TO: Jerry Davidson, Goode Perception Design Group
FROM: Elizabeth Steward, Associate Planner- Development Review
DATE: 5/12/26
SUBJECT: Parker Pointe F1 AMD 1 L3A - Huntington Bank

Staff Comments 02
SP25-138; Parker Pointe F1 AMD 1 L3A - Huntington Bank
Site Plan
May 12, 2026

LOT 3A PARKER POINTE SUBDIVISION FILING NO. 1, AMENDMENT NO. 1

HUNTINGTON NATIONAL BANK

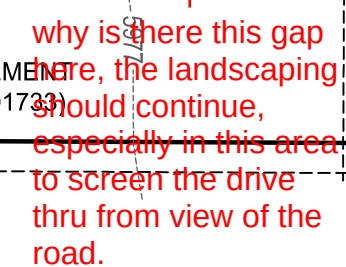
Comment on adding grasses referred to additional plantings in this area, similar to how mcdonalds minimized the seeding area to the maximum extent possible.

DESIGN HAS BEEN CHANGED TO
EXTEND & CONNECT BEDS ON
REVISED SUBMITTAL

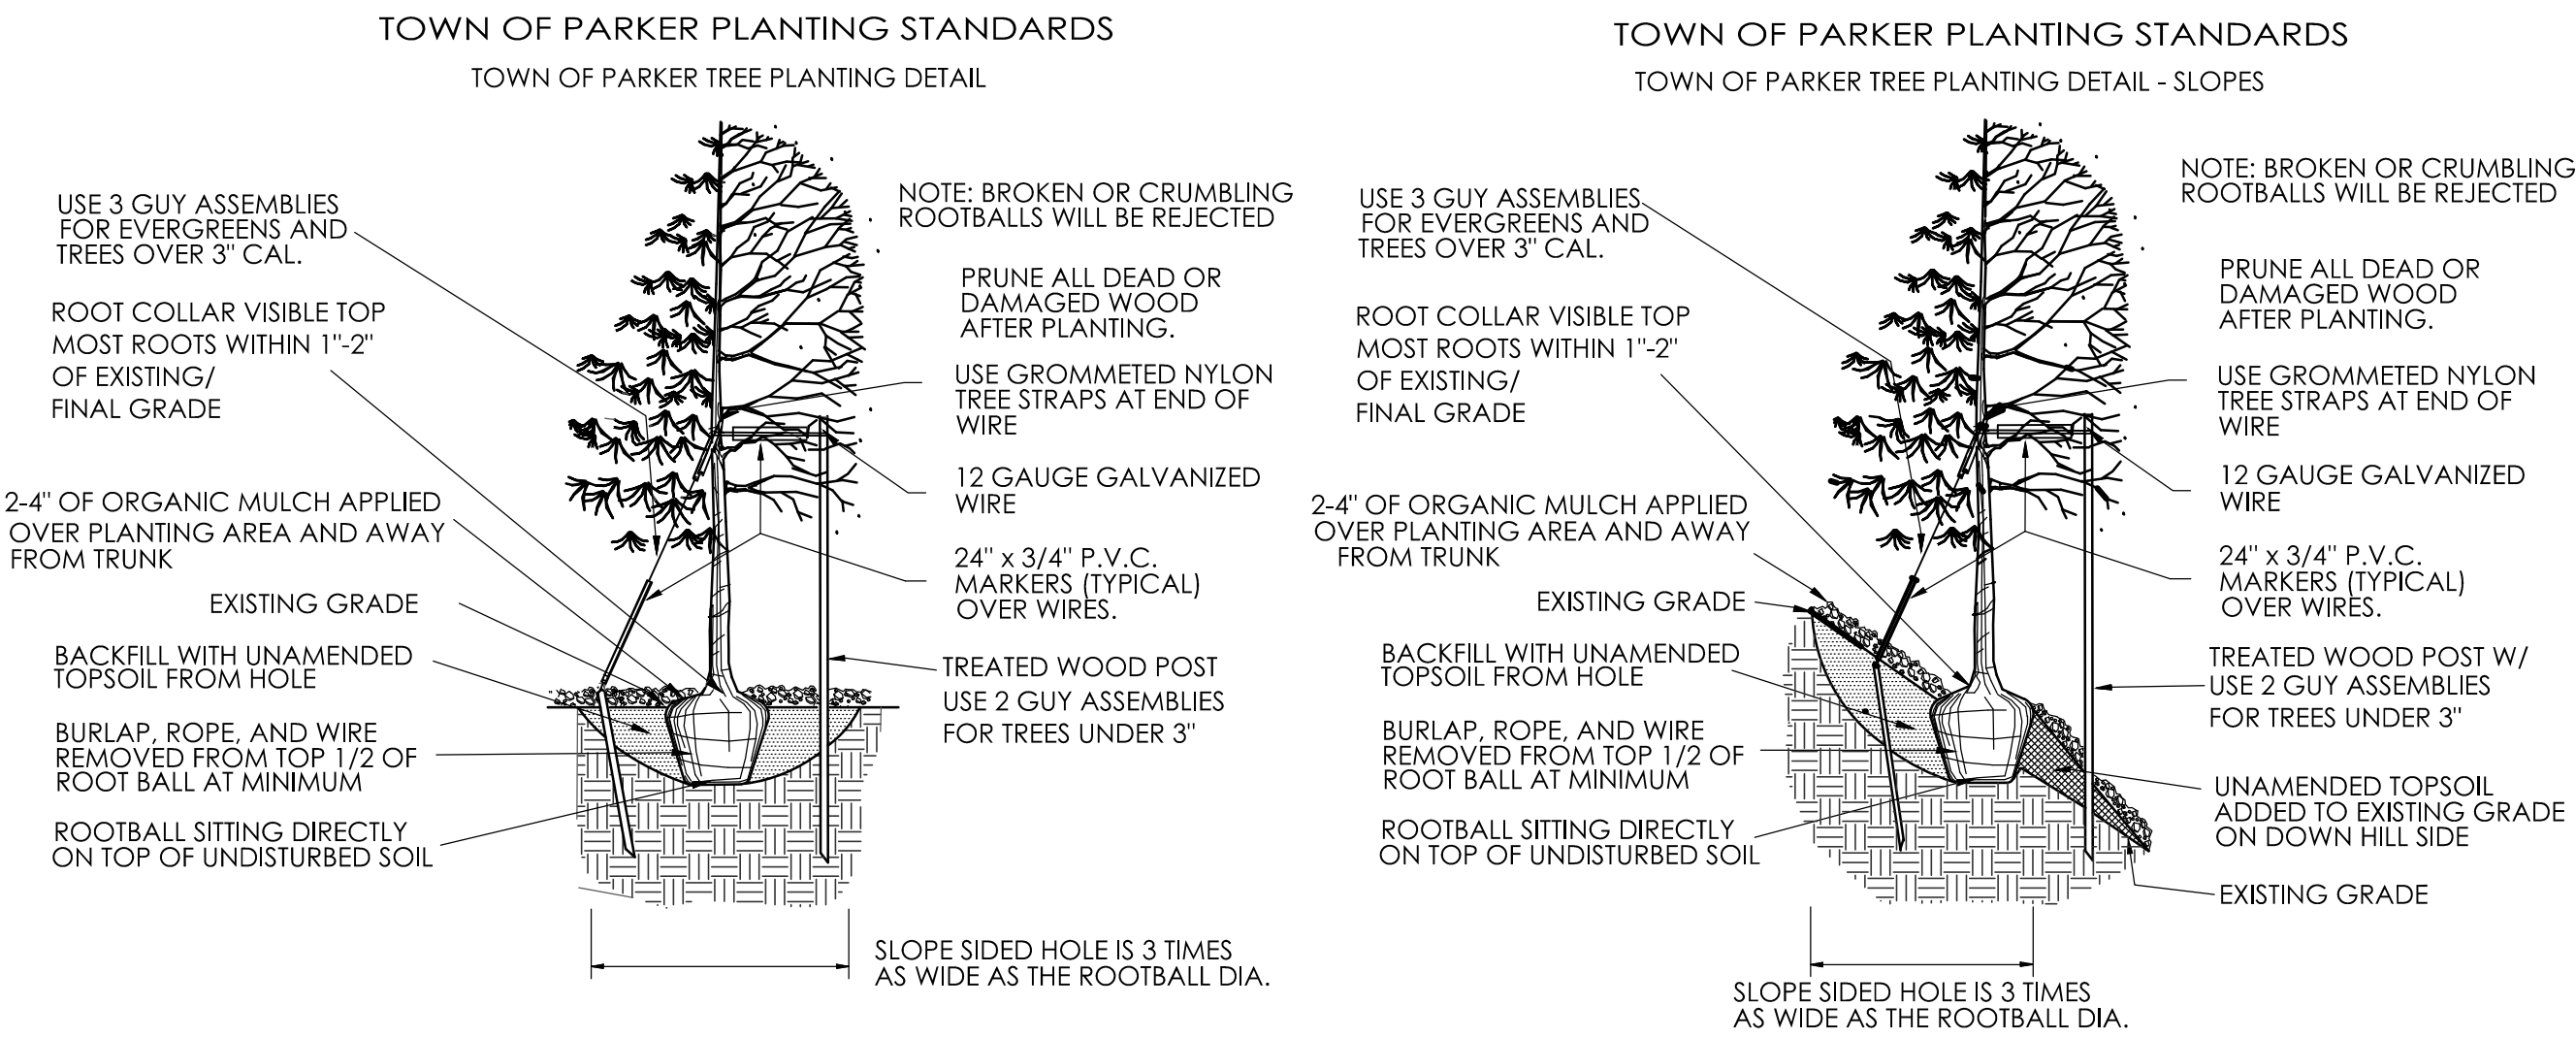
Apologies, I made an incorrect statement before, these are actually P2 required buffers as they are adjacent to ROW. They will require a 10 foot planting area with 1 tree and 5 shrubs per 25 linear feet, with 25% required evergreen.

REQ. TABLE AND DESIGN HAS BEEN CHANGED TO CONFORM TO THESE REQUIREMENTS ON REVISED SUBMITTAL

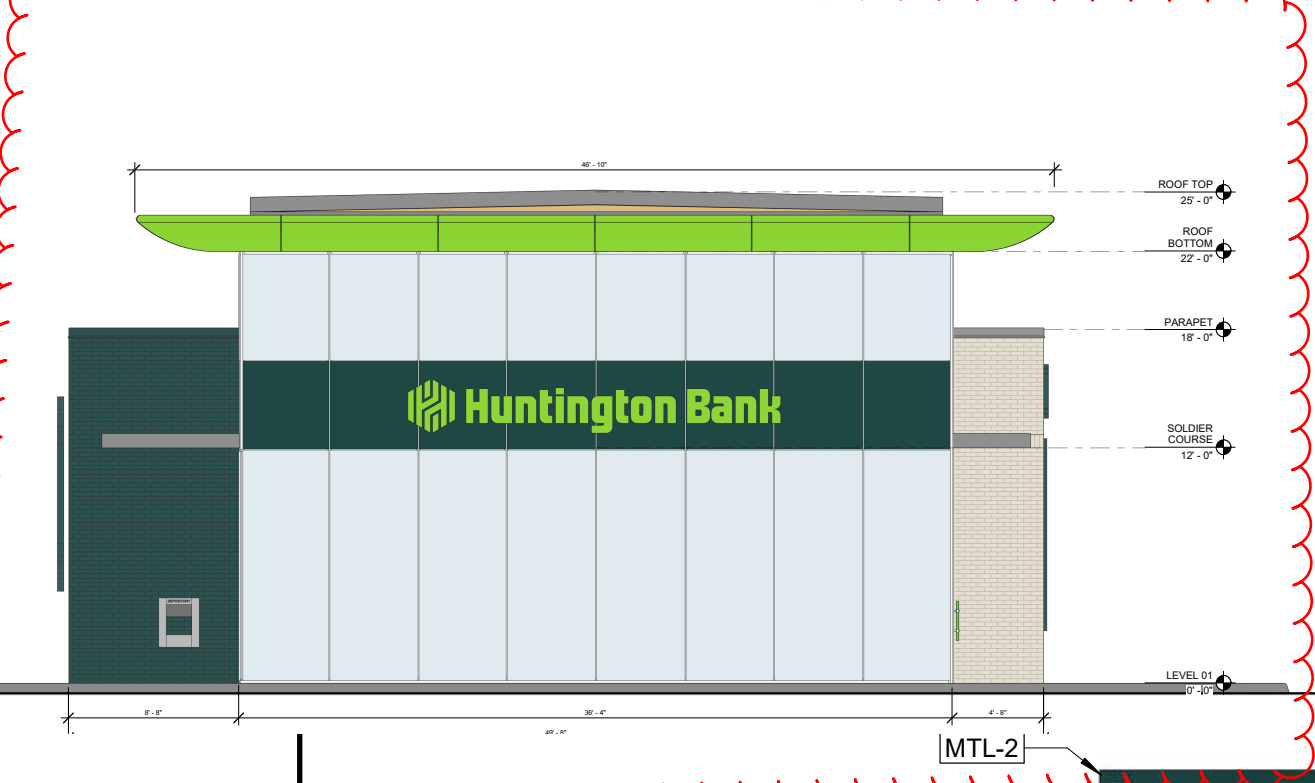
Why was this elevation so significantly changed? Staff had no comments on this side, it and the corresponding side view of this tower feature could be added back in the increase transparency and provide a corner feature for the side facing parker road and napa avenue

adding back in this roof feature here would count as a roofline change for the required vertical massing break at 25 feet for building facades less than 100 feet in length. Otherwise Buildings less than 100 feet in length shall require a vertical massing break at a distance of 25 feet on front and side bounding facades.
